Interpreting the paused test

Figure 1. User-supplied paused OLED test; the report transcribes its displayed values.

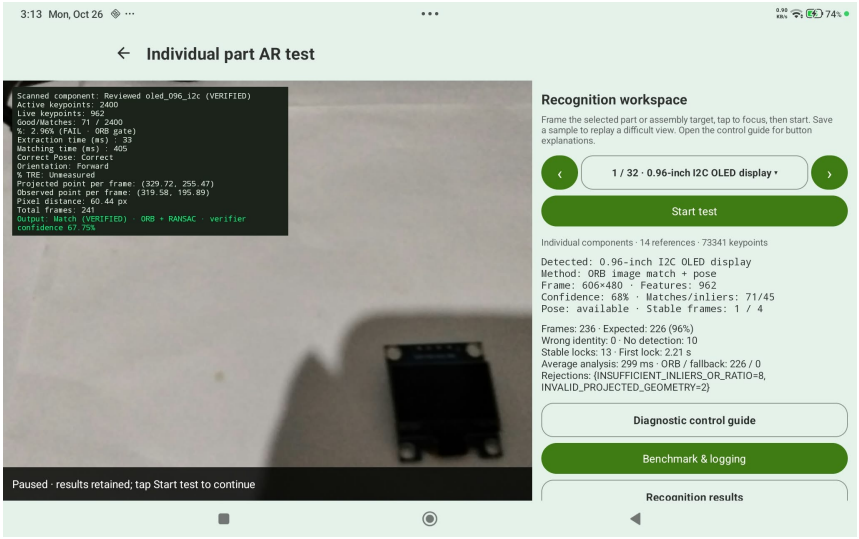
226 / 236 tester frames = 95.76%, displayed as 96%. This is the frequency of expected detections in this run, not ORB match yield or independently validated classification accuracy. The session shows 10 no-detection frames, 0 wrong-identity frames, 13 stable locks and a first lock at 2.21 seconds.

Stable frames: 1/4 means the displayed observation had not completed a new stability streak; earlier locks remain counted. **Total frames: 241** is the cumulative analyzer counter, whereas 236 belongs to this tester result group. Pause retained results; it did not convert the 85% gate into a pass.

The selected OLED was recognized repeatedly, and the displayed frame had spatially verified ORB evidence. The separate 85% yield criterion failed. This view does not establish a calibrated recognition probability, dataset-wide accuracy, physical seating or electrical continuity.

TRE remains Unmeasured without independent metric ground truth. The **60.44 px** center-to-inlier-centroid distance compares different point definitions; it is not solver RMS reprojection error. Extraction **33 ms** and matching **405 ms** describe the displayed frame, not the full human recognition task.

Report **match yield**, **RANSAC inlier fraction**, **recognition outcome** and **session detection rate** separately. The requested 85% yield rule is not a validated universal recognition-success criterion. Do not change counts, denominators or thresholds merely to obtain PASS; justify any future protocol revision using labeled positive and negative trials.
